ABU Robocon 2023 Phnom Penh, Cambodia

FAQ6

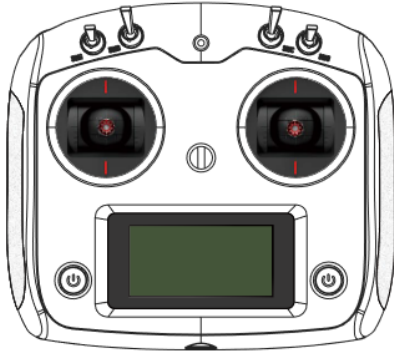
2.1-89	In rule point 2.4.4, we assume that when we try again, as long as the ring is on the robot's part, we can adjust its placement, one of which we	There is a revision of the game rule on 2.4.4: During the retry, team members cannot adjust the ring(s) held

|	put on the throwing area. Is that allowed? or when a retry must return all the rings in the robot to the ring zone? (INA)	by the robot. The ring(s) held by robot must be returned to any Ring Zones.
2.1-90	Before the start of the game during the setting time can we place ring stack as per our strategic orientation. Can we place axis of cylinder made by the ring stack is parallel to the field instead of perpendicular to it. (IND)	You can arrange the ring freely base on your strategy unless it won't go against the rule.
